SERVICE BULLETIN

Original Issue Date: **1/03**
 Model: **DXPower 1000™ Automatic Transfer Switches**
 Market: **ATS**
 Subject: **Control Board Failure in Some 480-Volt Applications**

Figure 1 Caution Tag

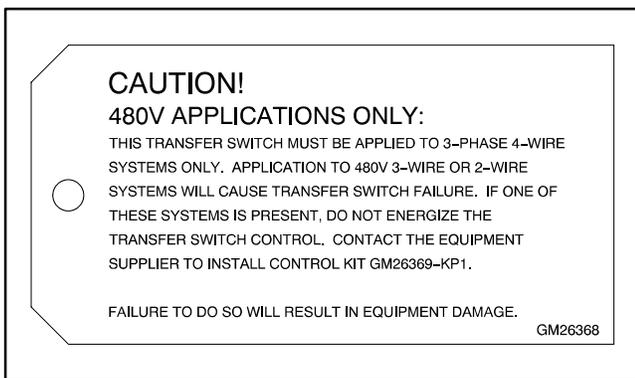
Transfer switches shipped from the manufacturer after September 15, 2002, have a red caution tag attached to the lead connector of the switch. The tag is shown in Figure 1.
